Solace of Colorado Springs (Lot 1) – Deviation Requests

- Paonia Street
- Galley Road Striping

DEVIATION REQUEST AND DECISION FORM

SOLACE APARTMENTS

DEVIATION EXHIBIT
SOLACE APARTMENTS
JOB NO. 25174.00
5/1/20
SHEET 1 OF 1

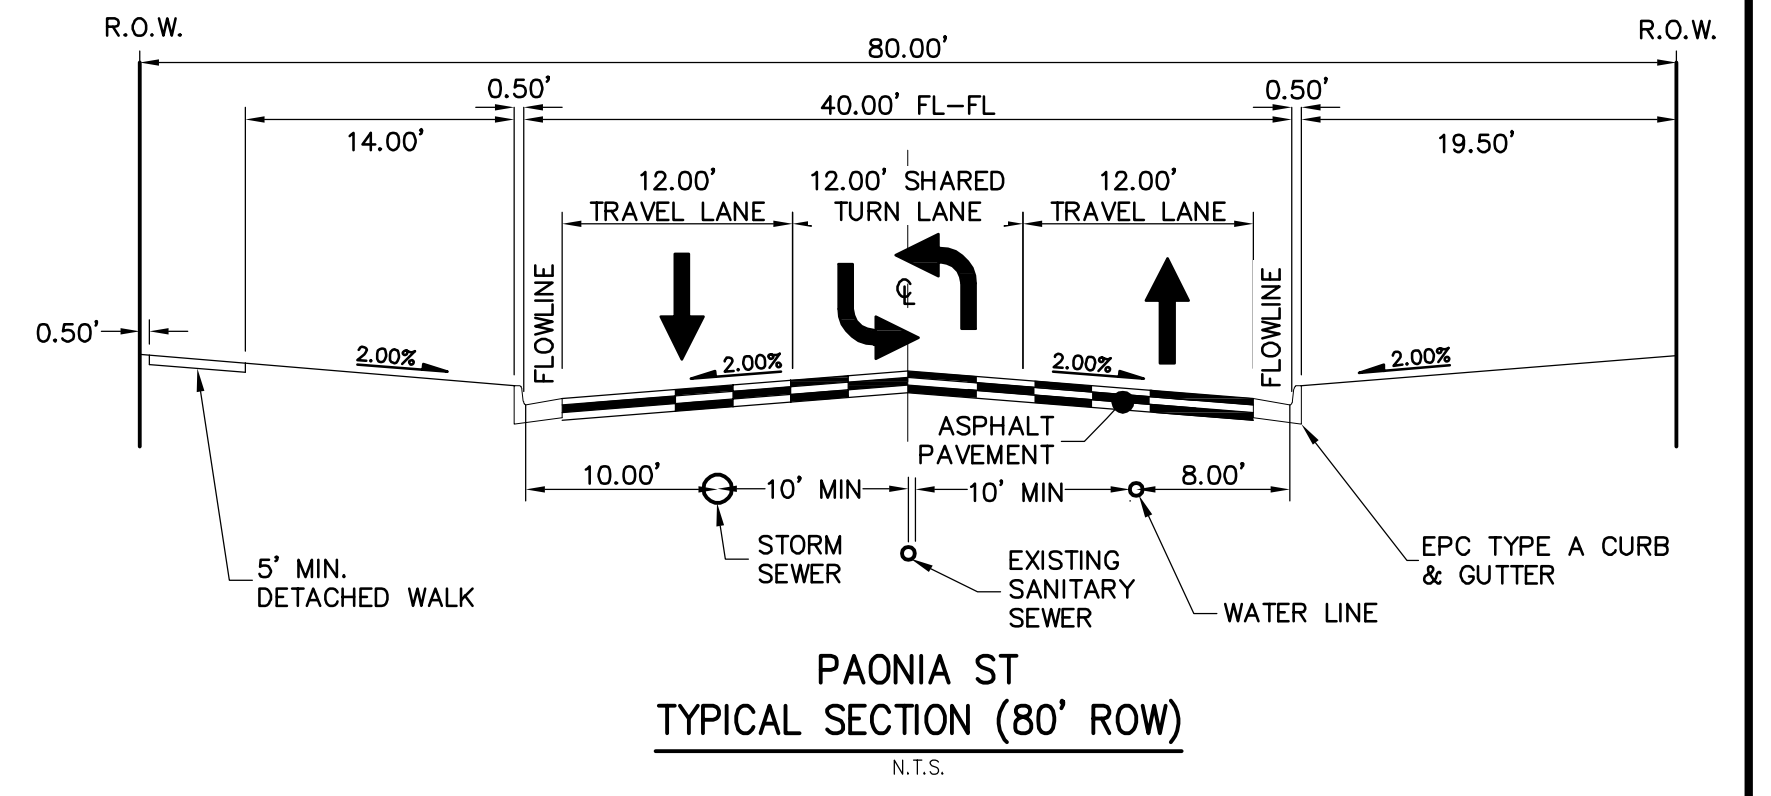
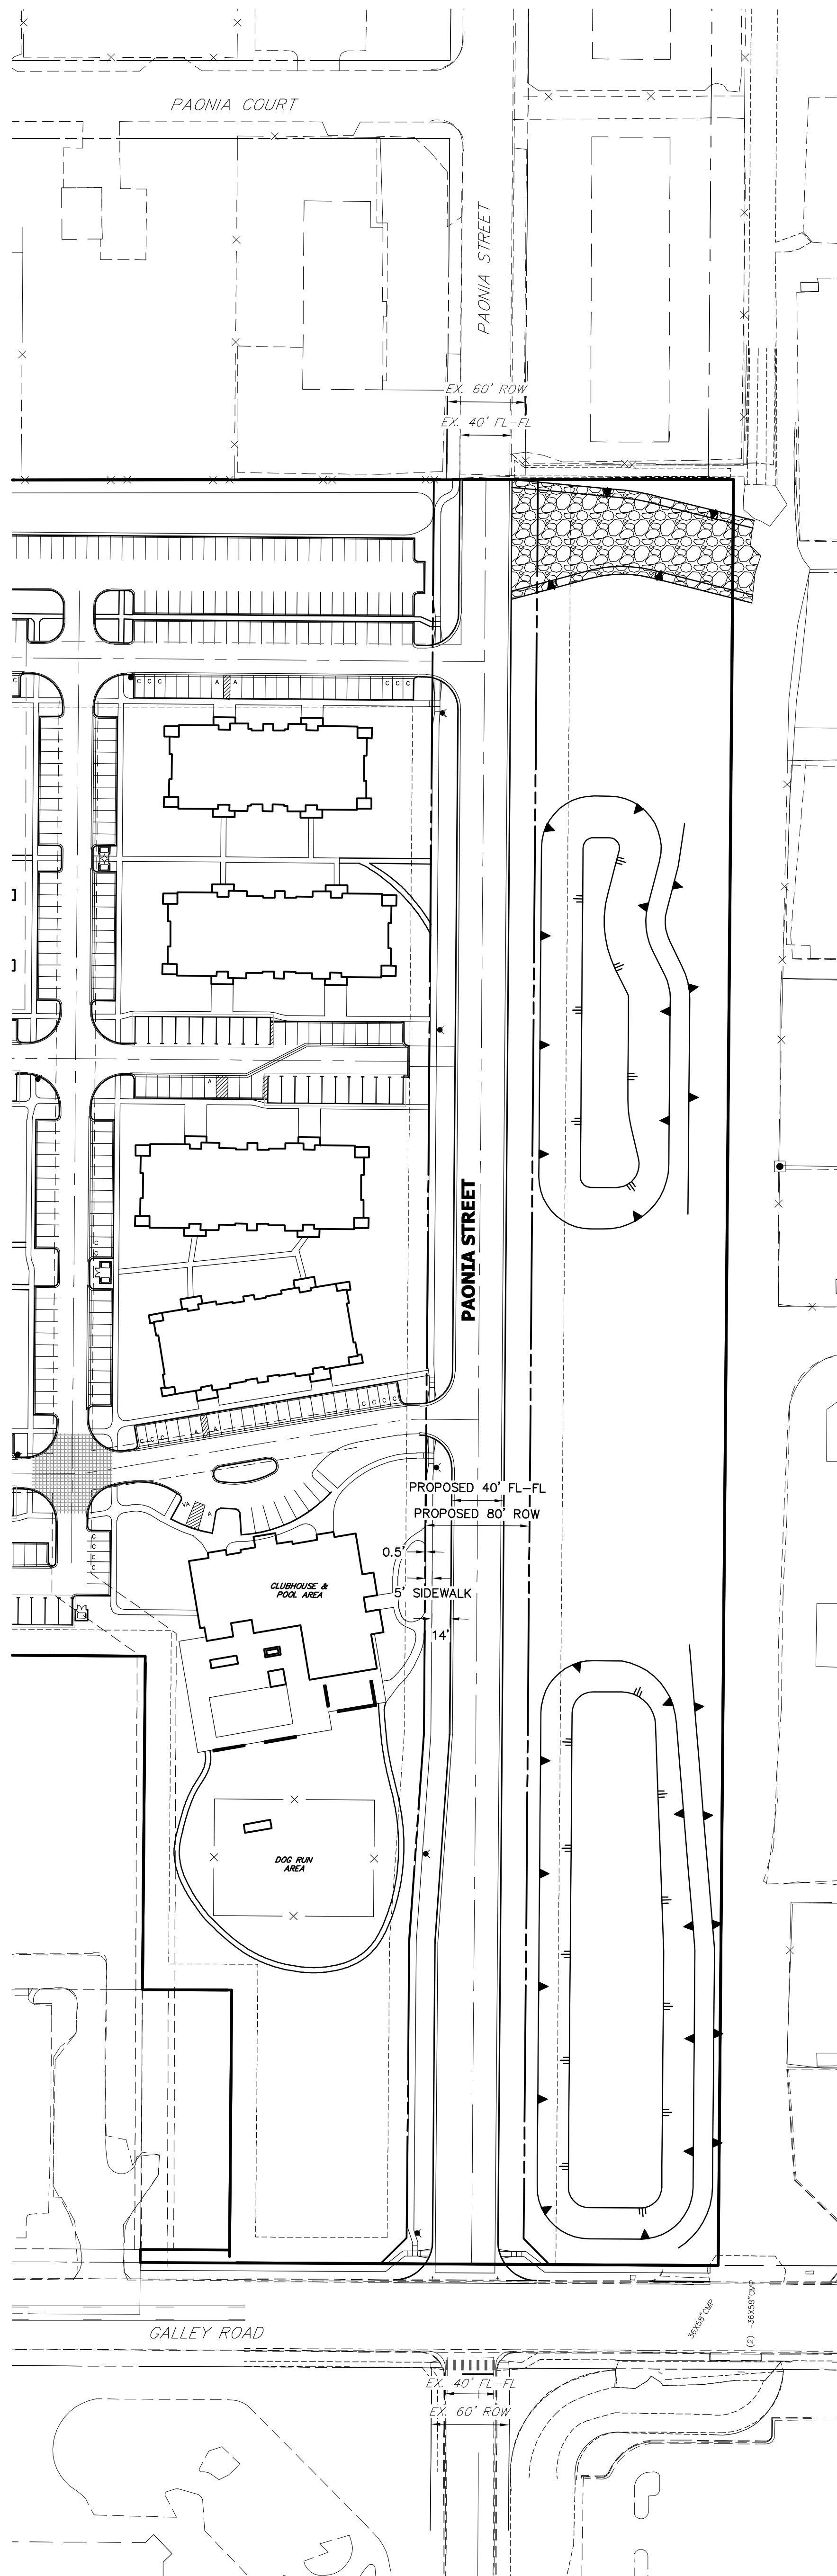
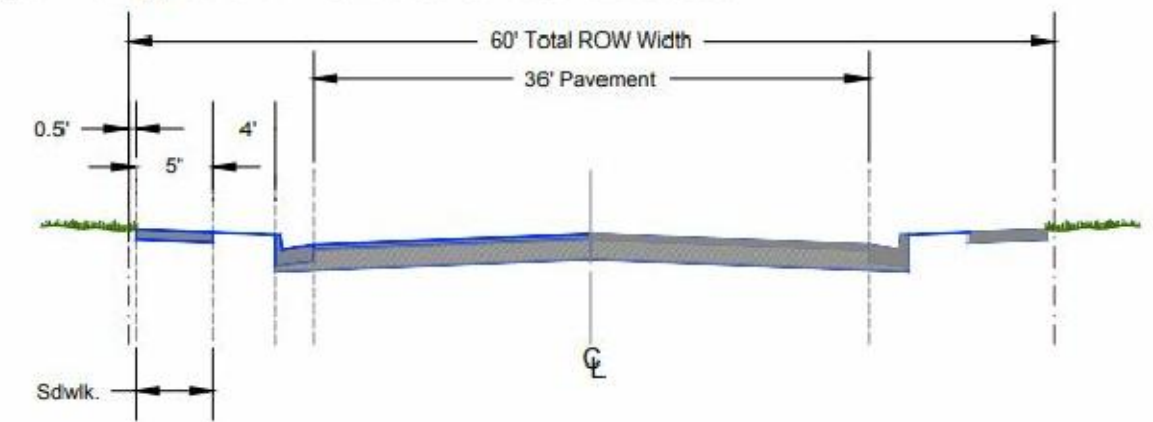
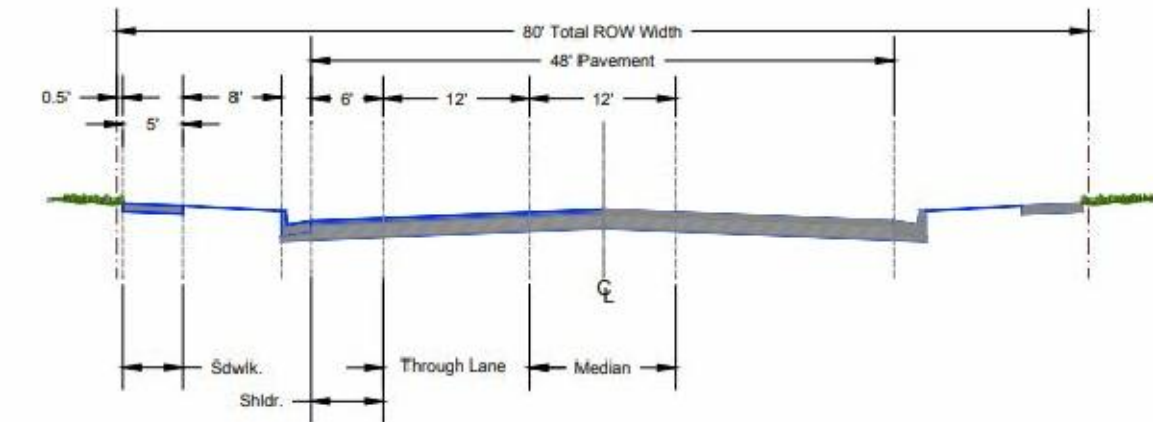
A deviation from the standards of or in Section **2.2.4.B.4 for Roadway Cross Sections** of the Engineering Criteria Manual (ECM) is requested.

An ECM criterion for an 80' ROW width (Urban Non-Residential Collector) typical section includes 48' of pavement (lip-lip) typical, typical curb and gutter, and 8' tree lawns with a 5' detached sidewalk on the west side.

The reason for the requested deviation of an alternate road section is that Paonia Street to the north and south of the development exists as a 60' ROW with 36' (lip-lip) pavement area. The proposed design is to maintain a consistent section through the Solace development and the entire Paonia corridor while still providing the requested 80' ROW of an Urban Non-Residential Collector. The walk is proposed on the west side to continue pedestrian movement from south to north through the corridor. No walks currently exist on the east side of the road, north or south of this development. Furthermore, there is currently no space for a walk to be considered in those existing developments due to the existing infrastructure. This removes the likelihood of any potential future connectivity for a walk on the east side of Paonia through this corridor. Although no walk is proposed, the horizontal space for a walk is still being dedicated should future redevelopment of this corridor warrant additional connectivity.

The proposed alternative is for Paonia Street to have an 80' ROW but the same road section as the "Typical Urban Residential Collector Cross Section" listed in Chapter 2, section 2.2.4.B.5 of the ECM. The only difference will be a 14' tree lawn instead of an 8' tree lawn due to the extra ROW width.

The ECM standard is inapplicable to the particular situation due to the fact that existing Paonia Street to the north and south of the development have 60' ROW with road section "Typical Urban Residential Collector Cross Section" listed in Chapter 2, section 2.2.4.B.5 of the ECM. This development would generate an estimated 2, 547 vehicle-trips during the day. This falls within the criteria specified in Table 2-7 specifying a design ADT <10,000.

This deviation will produce a development that interconnects with existing Paonia Street's typical corridor to the north and south. The standard section would unnecessarily interrupt the continuity along Paonia Street.

The deviation will not adversely affect safety or operations. Pedestrians will be further away from the traveled way with a larger tree lawn. Intersection crossings will have a reduced length meaning pedestrians will be in possible vehicle paths for less time, reducing risk of accidents.

Maintenance of the roadways will be positively impacted. The smaller roadway section, with less pavement mean long term pavement repair and maintenance cost savings. Similarly, the walkway not constructed on the east side of the road will reduce concrete repair and replacement costs. Long term intersection signalization costs will be reduced due to smaller poles & mast arms.

LEFT TURN LANE DEVIATION
SOLACE APARTMENTS
JOB NO. 25174.00
7/14/20
SHEET 1 OF 1

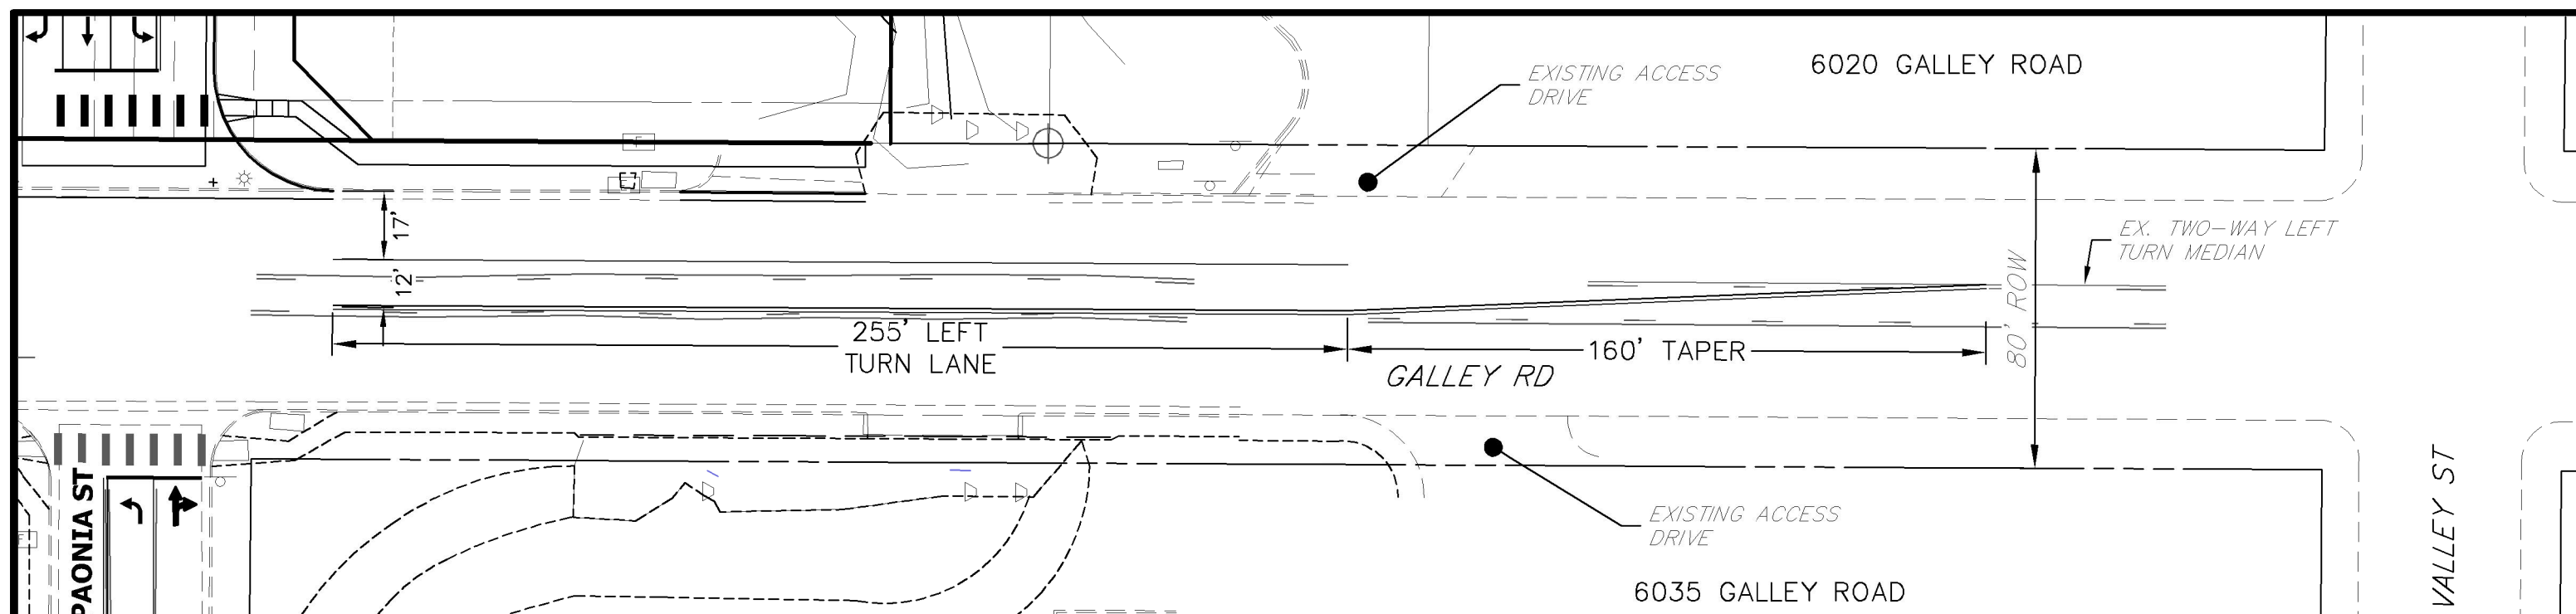
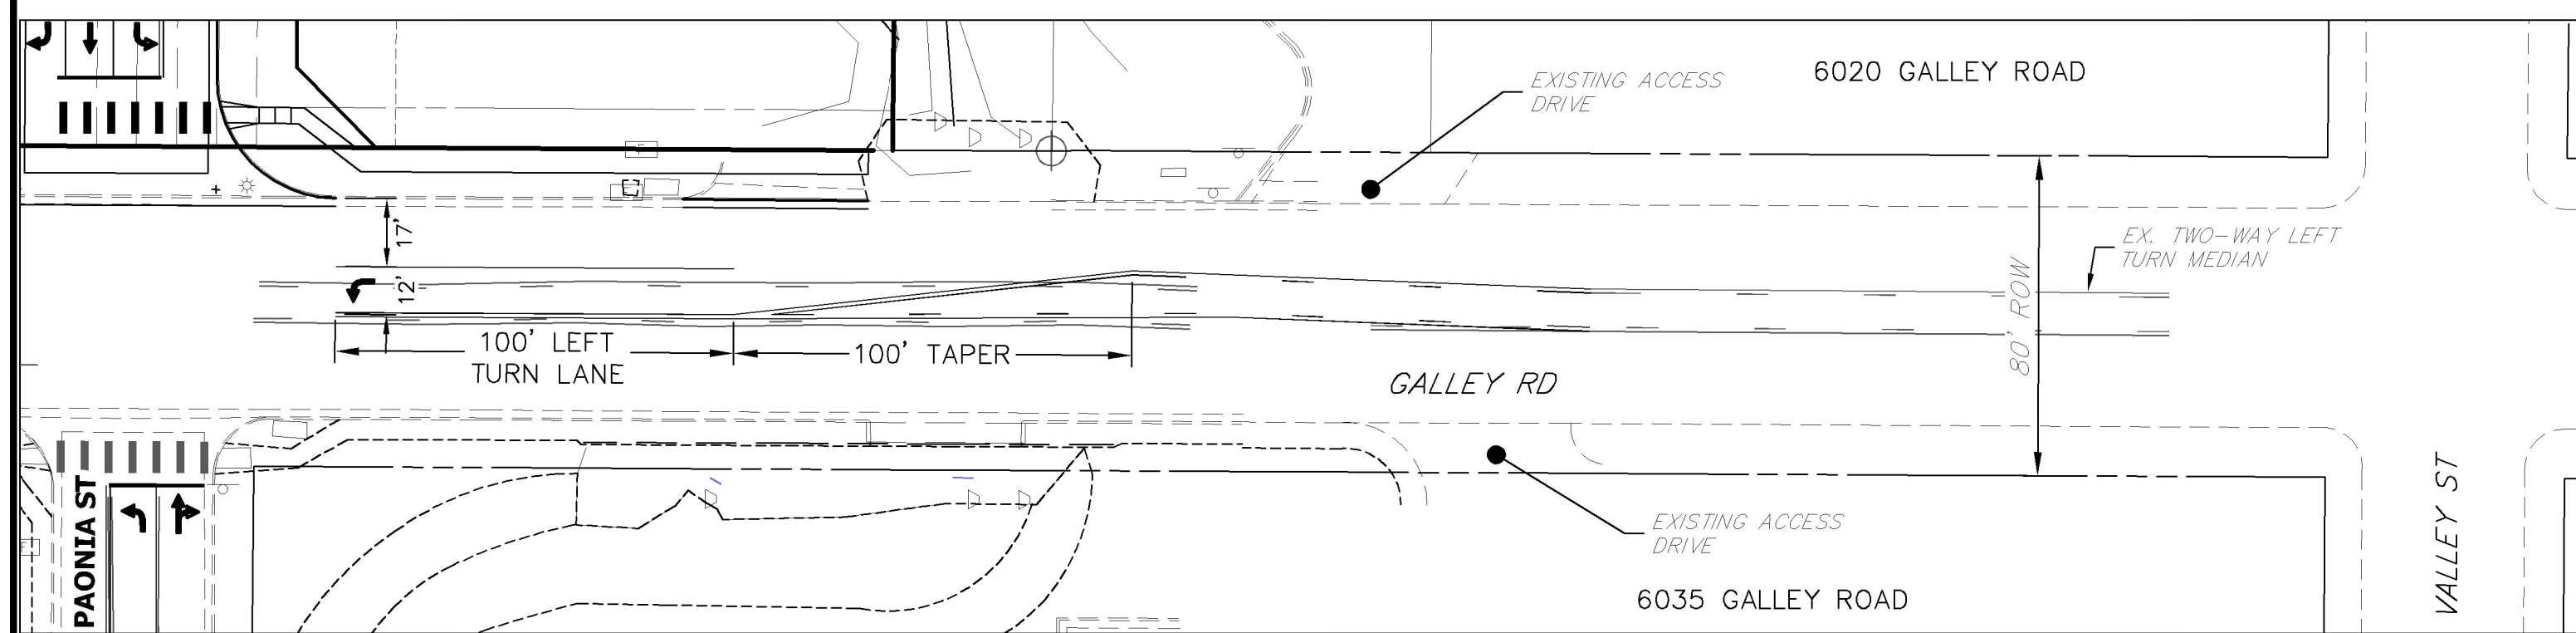
A deviation from the standards of or in Section **2.3.7.E for Turn Lane Design** of the Engineering Criteria Manual (ECM) is requested.

Required deceleration and taper length ECM criteria for a 155' lane length and a 160' taper from Table 2-26 for a 40 MPH design speed.

The reason for the requested deviation of a smaller left turn lane is to prevent restricting turn movements in and out of the surrounding businesses along Galley Road. Accesses for an existing parcel located at 6020 Galley Road and a parcel located at 6035 Galley Road would be directly impacted by the proposed turn lane. The deviation for the proposed design will provide adequate capacity for westbound traffic turning left onto Paonia Street while still providing full movement access to the businesses on the north and south side of galley Road. Per ECM criteria section 2.3.7.E.2 on page 2-53, the taper shall also meet the minimum 8:1 ratio. This removes the likelihood of any potential traffic conflicts through this corridor.

The proposed alternative is for the westbound left turn lane located on Galley Road at the intersection of Paonia Street to have a 100' left turn lane and a 100' taper for a total length of 200'. Typical turn lanes, per Chapter 2, Section 2.3.7.E of the ECM for a 40 MPH design speed, require a total length of 415'. Thus, the proposed alternative is 215'shorter than the standard.

The ECM standard is inapplicable to the particular situation due to the fact that existing developments to the north and south of Galley Road have access drives that would be impaired by the addition of a 415' left turn lane and this development should not restrict existing parcel access. The proposed shortened left turn lane would still supply adequate volume for westbound traffic turning left onto Paonia Street, while still allowing the existing access drives to the businesses along Galley Road to retain their full movement.

This deviation will prevent any negative impacts to the surrounding properties. A 415' left turn lane would block the accesses to existing businesses on both the north and south side of Galley Road. By shortening the left turn lane's deceleration lengths, any negative impacts to the existing businesses will be resolved while also removing conflict points at these access locations that will improve public safety.

The deviation will not adversely affect safety or operations. The existing roadway does not have a protected left turn lane at the intersection of Galley Road and Paonia Street. The proposed deviation will improve on the existing condition by adding a protected left turn lane, while still allowing the existing businesses along Galley Road to have full movement accesses. The shorter left turn lane will remove conflict points at these access locations reducing the chances of a collision.

Yes, the deviation meets the design intent and purpose of the ECM standards. There will not be an appreciable increase in the amount of traffic on Galley Road to necessitate the full left turn lane section. Per page 2-53, the taper shall meet the minimum 8:1 ratio. The existing access locations along Galley Road shall also not be impacted by the addition of the shortened left turn lane. They shall retain their full movement capabilities in order to prevent any adverse impacts to the local businesses.
